UNITED STATES PATENT AND TRADEMARK OFFICE

10/026,151

Office Action Summary

FIG. 2

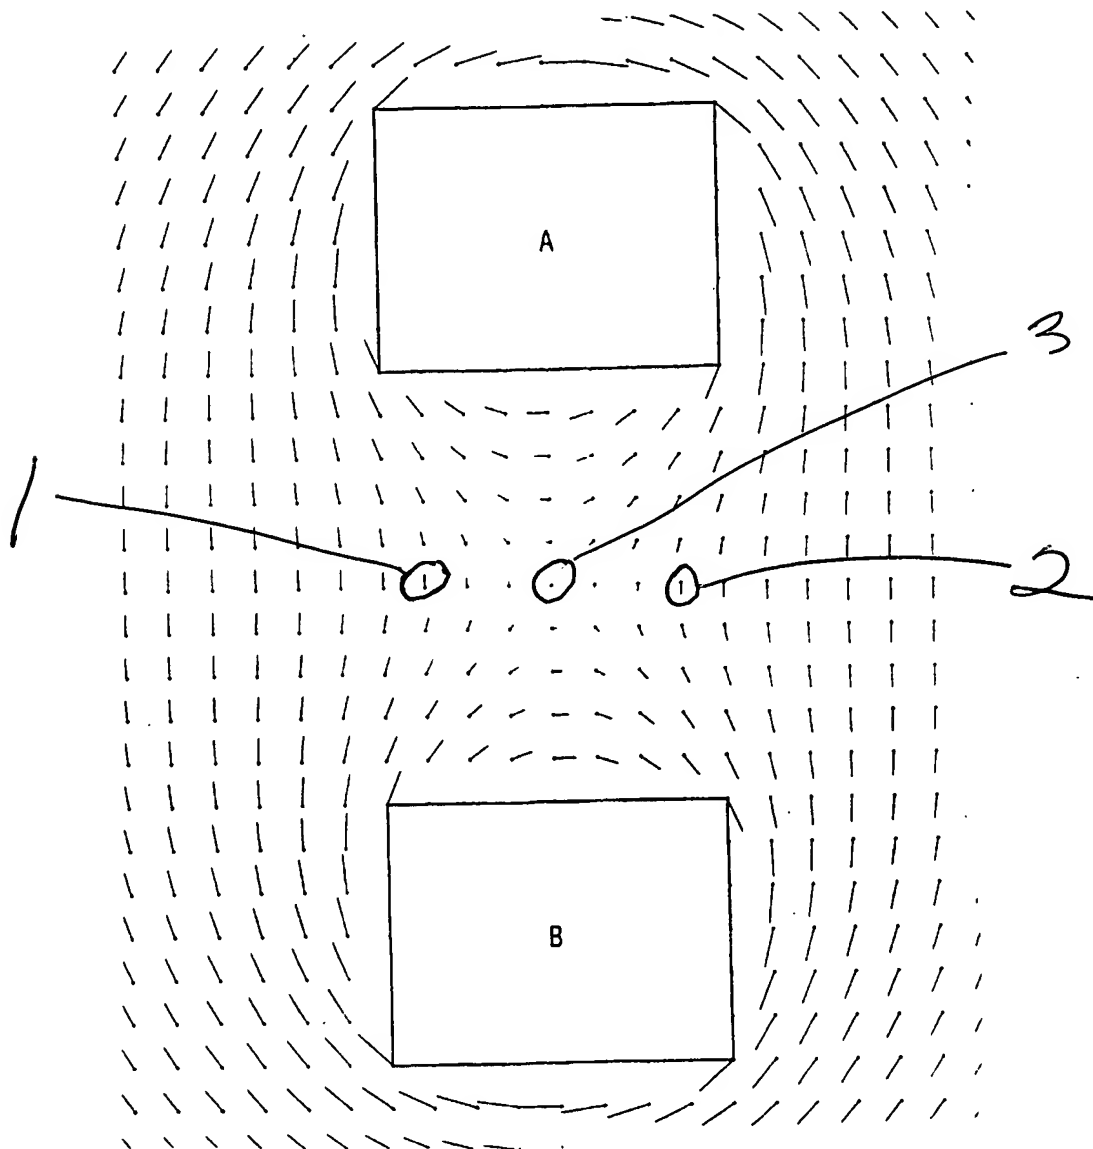
The above figure is Figure 2 of Ladds.

Claims 1-3, 6,7,10-13, 16,17, 20,30 and 31 are rejected under 35 U.S.C. 102(b) as being anticipated by Ladds. In Ladds, Figure 4 shows the position of devices H1 and H2 relative to conductors A and B. The Examiner has included a copy of Ladds Figure 2 above and has indicated positions 1, 2 and 3. Presumably H1 is at position 1 and H2 is at position 2. Ladds indicates that H1 and H2 could be positioned in various ways but seems to like the arrangement of Figure 4 best. The Examiner notes that the assembly of H1 and H2 could be rotated to any position about point 3 of Ladds Figure 2 and still be properly operational. Note that in Ladds, Figure 2, the arrow at position 1 is down and the arrow at position 2 is up. Ladds subtracts the output of H1 from H2 or vice versa to obtain 2 times the desired signal and cancellation of undesirable signals. The whole specification of Ladds is of interest. It is only 3.5 columns long. Further note that if the support for H1 and H2 of Figure 2 were rotated 90 degrees H1 and H2 would still be responding to up and down fields and that is why Ladds encompasses plural locations for the support (an IC package) for H1 and H2.
